Date: October 30, 2002
 To: T10 Technical Committee
 From: Alvin Cox (alvin.cox@seagate.com)
 Subject: SAS Test Loads

The following changes to text and test load figure are made to aid the testing process by clarifying and defining the compliance channel test load and zero-length test load. The changes to the rev 0 version are significant and not highlighted in an effort to make this version more readable. Revision 2 adds a statement explaining the purpose of compliance channel testing.

Figure 39 — Test Transmitter test loads

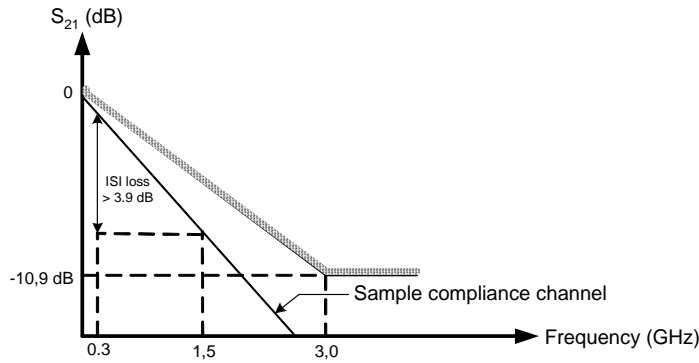
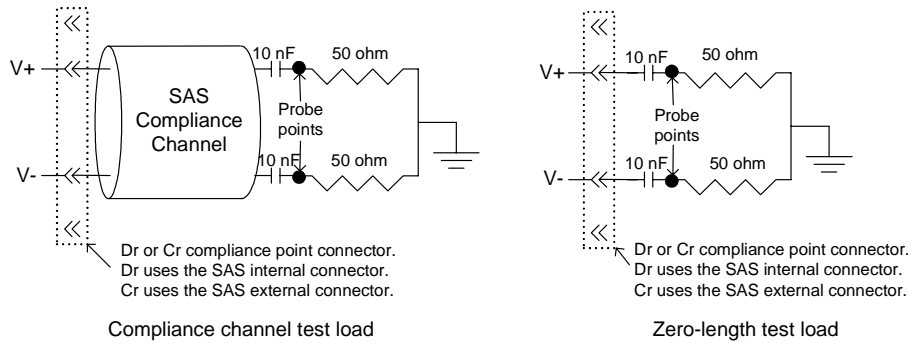
The driver shall have the output voltages and timing listed in table 24 25 and table 26 measured at the designated interoperability points. The default mask is **Cr** for inter-cabinet TxRx connections and **Dr** for intra-cabinet TxRx connections. The measurements shall be made across a load equivalent to **the zero-length load that** shown in figure 39 **unless otherwise specified**.

The driver shall also meet the output voltages and timing listed in table 25 and table 26 at the designated interoperability points. The default mask is Cr for inter-cabinet TxRx connections and Dr for the intra-cabinet TxRx connections. The measurements shall be made across a load equivalent to the compliance channel test load shown in figure 39 unless otherwise specified. The transmission magnitude response, [S₂₁], of the compliance channel in dB satisfies the following equation:

A compliance channel magnitude response and ISI loss example for 3 Gbps is shown in figure 39.

The eye masks are shown in 5.7.4. ~~The normalized amplitudes, Y1 and Y2, allow signal undershoots. The driver shall meet both the normalized and absolute values.~~
